10 Mb/s Single Twisted Pair Ethernet 10BASE-T1L Receive State Diagram Disparity Error

Steffen Graber
Pepperl+Fuchs

10BASE-T1L Receive State Diagram

Changes (in red) to:
 Figure 146-8 – PCS receive
 state diagram (part a)

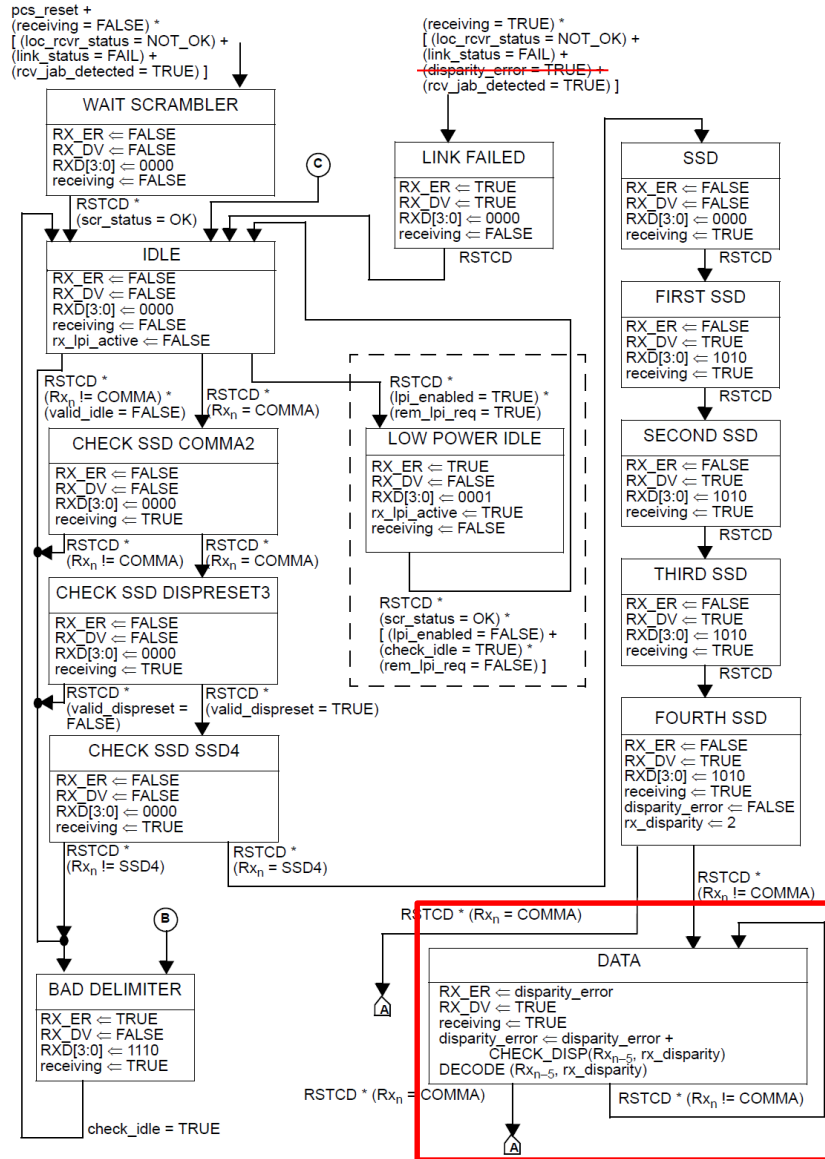
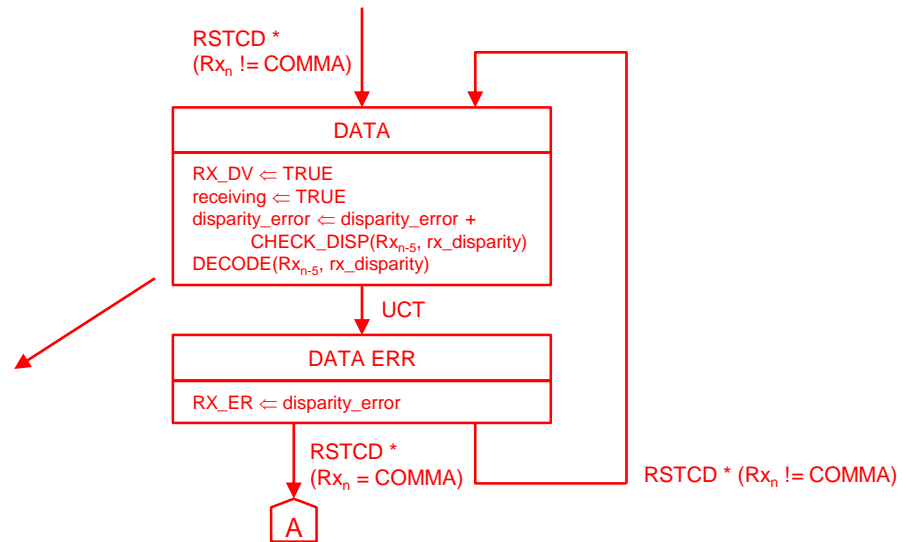
- The PCS receive state diagram in Draft D2.1 has several states (DATA, CHECK ESD COMMA2, CHECK ESD DISPRESET3, and CHECK ESD ESD4), where the variable `disparity_error` is modified, but also used in the same state.

- As the equations provided in a state are only executed once the state is entered and as the order of the equations within the state is not relevant for the order of the command execution, it is not clear, if `RX_ER` is using the old value of the `disparity_error` variable or already the updated value.
- To prevent this unclear situation additional states for setting `RX_ER` are introduced.
- In state ESD there is no update of the `disparity_error` variable necessary, therefore a simple “or” condition can be used:

- Additionally some minor corrections in two transitions of the state diagram are done.
- All changes can be seen on the next two pages.

$$\text{RX_ER} \leftarrow \text{disparity_error} + \text{CHECK_DISP}(\text{Rx}_{n-5}, \text{rx_disparity})$$
